## Stage 2 Road Safety Audit

### Stretford Public Realm Improvements – Phase 1

CO00201045

June 2017

## Junctions

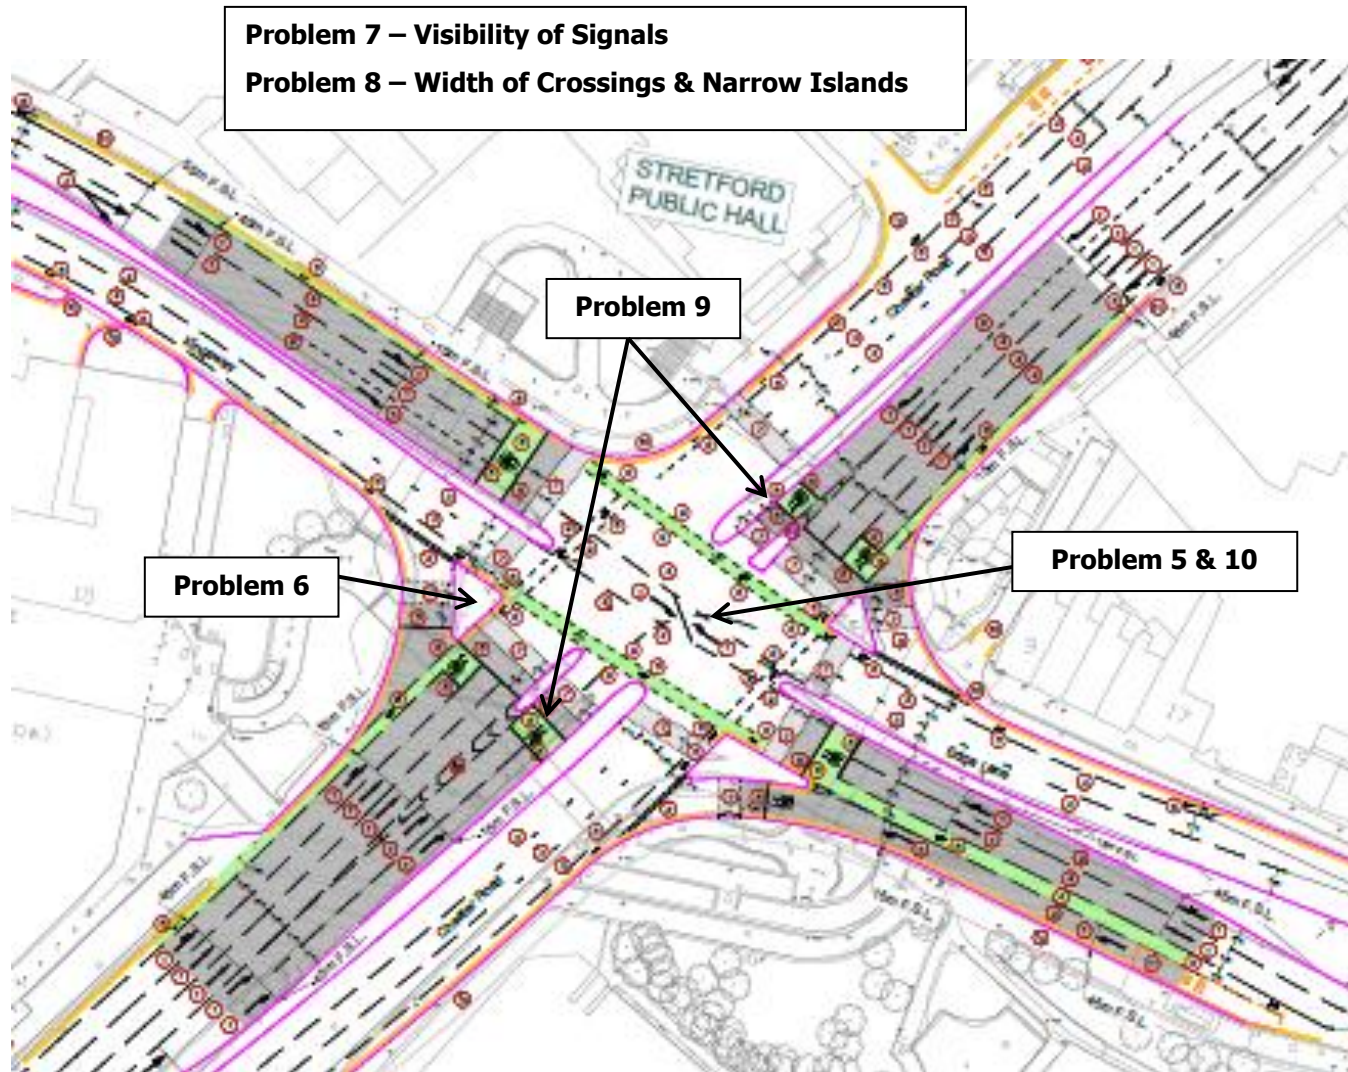
**Detail:** No details of the signal phasing has been provided and if there is no allowance for a right turn phase from Kingsway or Edge Lane then this may lead to conflicts within the junction as drivers would have to seek gaps in the oncoming traffic which is particularly unsafe for cyclists.

**Detail:** It is common for pedestrians to misread the nearside push button units on splitter islands if the signal poles are not orientated very well or they are close together. Without any signal phasing details it is not clear how the pedestrian phase will operate, however when Kingsway is given a green man pedestrians waiting to cross Chester Road may misread the signal and start to cross resulting in pedestrian / vehicle conflicts.

**Detail:** This is a busy multi-lane junction with 4 lanes on each approach on Chester Road. This is increasing to 5 lanes on the north-east bound approach. Without specific signal details it is unclear what type of signal will be installed. The Audit Team are concerned that if tall poles or mast arms are not used there is the potential for the signals to be missed if there is queuing traffic resulting in vehicle collisions within the junction.

**Detail:** The Audit Team are concerned about the overall width of the crossings especially on Chester Road and the time it will take to cross. The road is well over 15 metres and guidance suggests that if that is the case staggered crossings should be considered and approval is needed. Also, the central islands are approximately 2 metres wide which is insufficient to safely accommodate the anticipated number of pedestrian flows expected. It may also lead to damage to the signal assets in this locality if there is not sufficient clearance.

**Detail:** Without any phasing detail it is assumed that the main road traffic will be held on red whilst the right turn traffic will run. Pedestrians waiting in the central reservation may look at the far side and think that all the lanes have been held on red and start to cross with a risk that they will step out into the path of right turning vehicles.

**Detail:** Drawing NO: CO00201045-P1-1200-01 shows right turn pockets in the centre of the junction with right turn arrows. The lining for the right turn from Edge Lane in particular leads drivers between the island and central reservation which creates the right turn lane from Chester Road to Kingsway. Although Drawing No: CO00201045-1300-01 indicates a bollard it is not clear if this will have a keep left sign on it.

Design Team Response (TfGM)(1): The staging and phasing arrangements were included in the traffic signal design layout supplied by TfGM. The staging was agreed with Trafford Highways following the modelling of the junction. This was carried out by TfGM on behalf of Trafford and showed no requirement for a right turn arrow from either Kingsway or Edge Lane. There are many other junctions with opposing right turning vehicles without a green arrow.

Design Team Response (TfGM)(1): The staging and phasing arrangements were included in the traffic signal design layout supplied by TfGM. The pedestrian phase (phase R) will appear, if demanded, during both stages 1 and 2. Narrow field of vision units (NFOV's) have been included for all crossing points where it is felt there could be confusion for pedestrians.

**Design Team Response (TfGM)(1):** The signal details for all approaches were included in the traffic signal design layout supplied by TfGM. The NE bound approach is a 3 ahead and 2 separate right turn lane approach and will be signalised accordingly. There are to be 3 ahead signals for motorists to observe going straight on, 3 right turn signals into Edge Lane and 2 left turn signals into Kingsway complete with illuminated TRO's where applicable. The signal heads will be LED and are much clearer and brighter than the older halogen signals. The junction will be fitted with a solar cell which will regulate the brightness of the signals dependent on the conditions.

Design Team Response (TfGM)(1): The crossings over Chester Road are to be 1 phase and the green time for the pedestrians will be calculated such that this can be achieved in 1 movement. This should mean that on the majority of occasions, most of the pedestrians will be able to cross the whole distance. The splitter islands are included to provide a physical separation between the ahead and right turning vehicles and act as a refuge for any pedestrians who start to cross on the change from green man to red man and cannot manage to complete the crossing in 1 movement. To provide a staggered crossing in these locations would require the removal of a traffic lane on each approach.

Design Team Response (TfGM)(1): The staging and phasing arrangements were included in the traffic signal design layout supplied by TfGM. The assumption that the right turning movements on each of the Chester Road approaches will be independent of the ahead traffic is incorrect. The right turn movements will only appear with the ahead traffic.

Design Team Response (TfGM)(1): No entry signs cannot be installed on the traffic signal heads as these will not be a Greater Manchester Combined Authority (GMCA) asset. Under the terms of the TfGM agreed contract, the mixing of equipment on traffic signal poles is not permitted. Right Turn bollards are proposed as part of this scheme.

## Non-Motorised User Provision

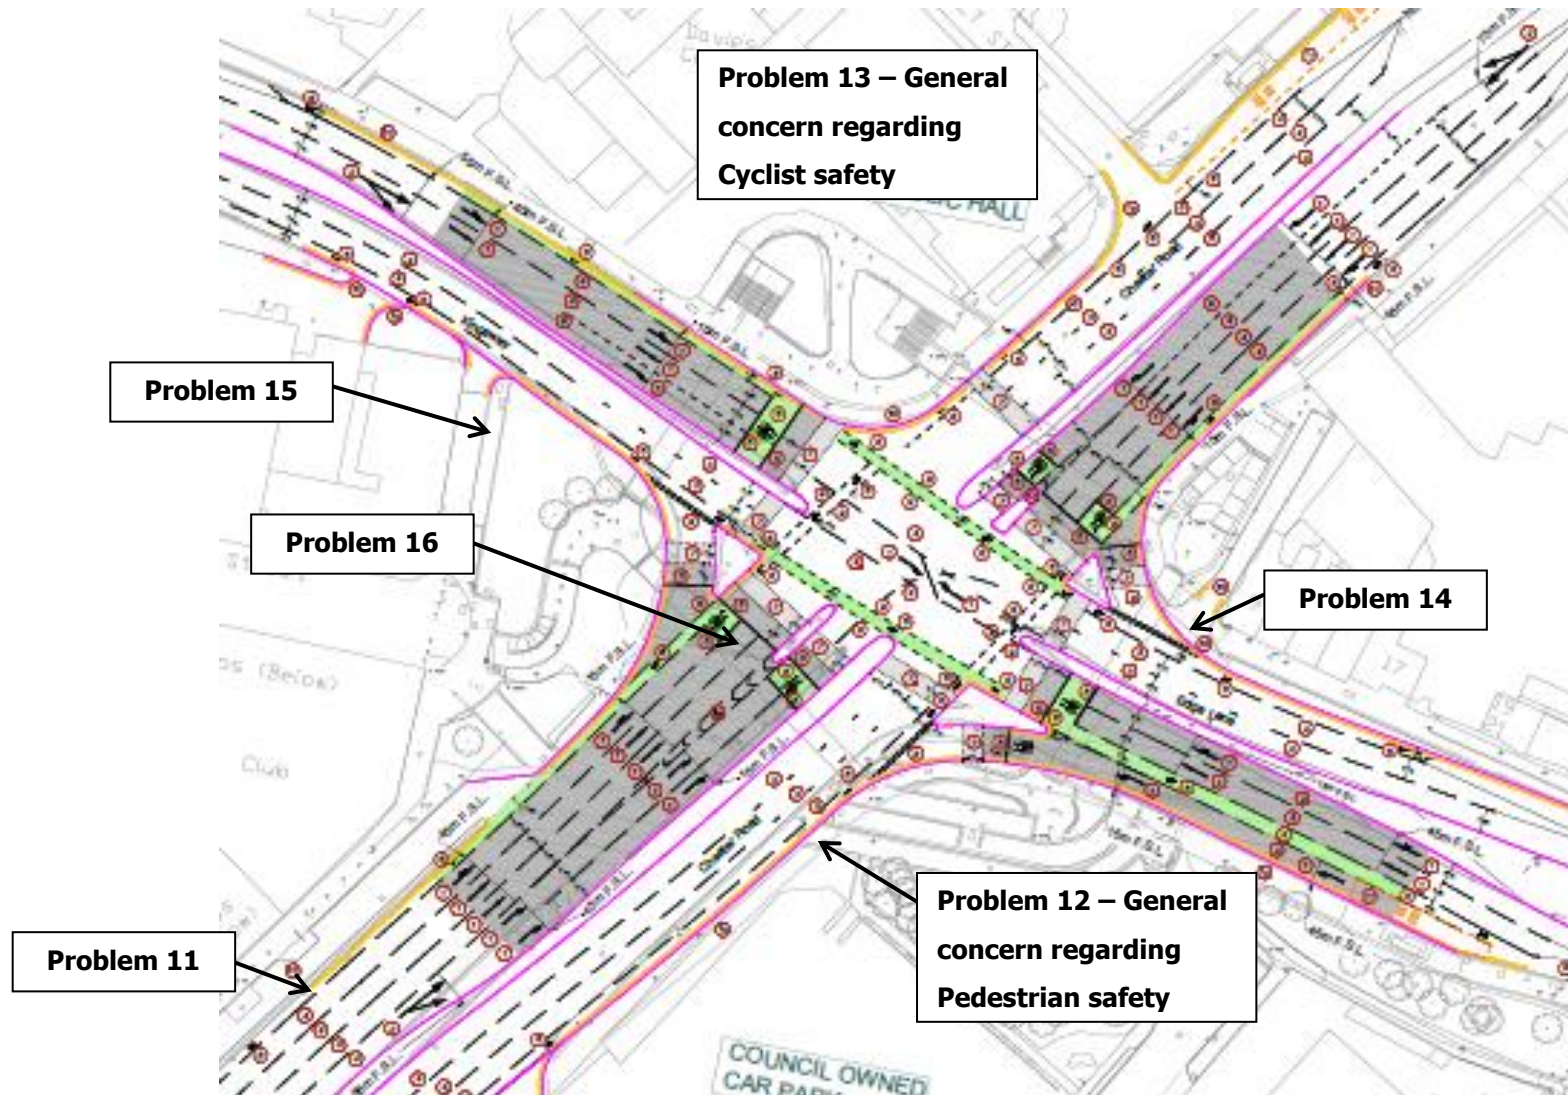
**Detail:** Drawing No: CO00201045-P1-1200-01 shows the cycle lane at 1.3 metres wide which is substandard especially on such a busy road. It does increase to 1.6 metres but it is unclear over what distance it remains at 1.3 metres. There is an existing conflict area at the end of the bus lane after the access under the building where buses and vehicles merge. The cycle lane at this point is only 1.3 metres wide and due to the kerb alignment this makes them very vulnerable.

**Detail:** Currently pedestrians and traffic are kept apart at the signal controlled junction by means of the existing subways. The proposal is to provide at grade signalised crossings on all four arms of the junction and remove three of the four subways and significant lengths of pedestrian guard rail. This will bring them closer to high volumes of traffic on wide multi-lane carriageways.

**Detail:** There are no specific off road facilities for cyclists; they are to remain using the carriageway by means of cycle lanes and advance cycle reservoirs at the signals. Cyclists can be vulnerable especially when left turning traffic crosses the path of cyclists going ahead using on carriageway cycle lanes and when they are turning right. This is a busy wide junction with a high volume of traffic and the posted speed limit on Chester Road is 40mph. It is not clear from the information if there will be an early start in the signal phasing for cyclists.

**Detail:** Drawing No: CO00201045/P1/1100/001 shows new footway construction and kerbing across the junction for the small access road off Edge Lane. Although this is only an access to the parking at the rear of the first few properties, it is assumed that this will still be needed and cars coming round the corner from Chester Road have to make a quick turn to avoid being shunted from behind. There is no proposed delineation between the footway and carriageway and pedestrians maybe unaware of the road. At present there is some tactile paving but there are no details to show that this will be installed as part of this scheme. Cyclists also use this footpath and there are no details for any give way lining as there is at present.

**Detail:** Drawing No: CO00201045/P1/1100/001 shows the new pedestrian and landscaped area outside the shopping mall which is acceptable for pedestrians taking a direct route from the shops across Chester Road or heading north or south-west. However pedestrians coming from Kingsway heading towards Edge Lane have an indirect route around the landscaping to get to the new crossing facility. There is a risk that they may choose the desire line which is across the landscaped area resulting in trips and falls if the area becomes wet or is uneven and become a future maintenance liability.

**Detail:** Drawing No: CO00201045\_P1\_100\_011 shows a temporary pedestrian route at the rear of the car park along and out of Newton Street. This is acceptable for pedestrians heading from Edge Lane to Chester Road in a south-westerly direction but does not take account of pedestrians crossing Chester Road from the shopping mall heading towards Edge Lane whilst the subway is being filled in. Pedestrians will either have to walk a very long way round or risk crossing a very busy road without any pedestrian facilities.

Design Team Response (1): Existing cycle lanes are 0.85m at this location and all proposed cycle lanes have been designed to best accommodate widths of 1.5m (as recommended by Greater Manchester Cycling Design Guidance) throughout the approaches and exits of the junction. The area in which the 1.3m measurement was made is on the boundary of the scope of works and therefore the lane marking alignment is in transition of tying into existing road markings (cycle lane of 0.85m width). A review will be undertaken to attempt to maintain cycle lane widths of 1.5m along this stretch of road through the conflict area.

Pedestrian guardrail is proposed within pedestrian traffic islands and at staggered pedestrian crossing points. Guardrail is also proposed on both the north western and north eastern radii due to the installation of containment kerb which will create a significant height difference between footway and carriageway surface levels. The south western corner of the junction has architectural fencing proposed along the proposed lawn boundaries.

Design Team Response (TfGM)(1): Shared footways would involve a major re-construction of the existing footways complete with widening to meet the minimum requirements. At no point during the design of this junction have Trafford Highways requested the provision of toucan facilities. To include toucan crossings would involve a complete re-design in co-ordination with Trafford Highways. In Greater Manchester, early starts for cyclists cannot be included where there are opposing right turn vehicles as it is considered unsafe. In addition, each traffic movement at this site would have to have its own stage and this will be detrimental to capacity.

Design Team Response (1): The access leads to a piece of land with an area of 247m<sup>2</sup> (19m x 13m). This land is occupied by no more than six vehicles at a time. The access is not considered to conflict with pedestrians frequently. Due to low volumes of traffic, this road has been downgraded from a road to a vehicle access which has a ramped entrance (to provide continuity of footway level) which will cause vehicles to slow down. Vehicles turning left from Chester Road (south bound) will be undertaking their manoeuvre slowly due to the severity of the left turn. Visibility on the approach is good and therefore the risk of conflict with pedestrians is deemed to be low.

**Design Team Response (1):** it is accepted that a desire line for pedestrians travelling from Kingsway to the southern arm of Chester Road is not reflected within the landscape design. The landscaping element of the scheme is a major feature and has been designed with the attempt to remove the existing 1960's, heavily engineered character of the area. The scheme intends to provide a pleasant public realm environment for the local residents and visitors to the area. The existing route to cross Chester Road (southern arm) consists of a none DDA compliant ramped access to the southern subway which will take a pedestrian longer to undertake their journey doing the same route when compared to the new proposed route they would have to undertake. Clear delineation has been proposed between footway and grassed lawn areas so that any pedestrians opting to undertake a short cut would be doing so at their own risk and are deemed not to be exposed to concealed tripping hazards.

**Design Team Response (1):** It is anticipated that pedestrian journeys are going to be significantly disrupted in terms of distance to cross the roads safely.
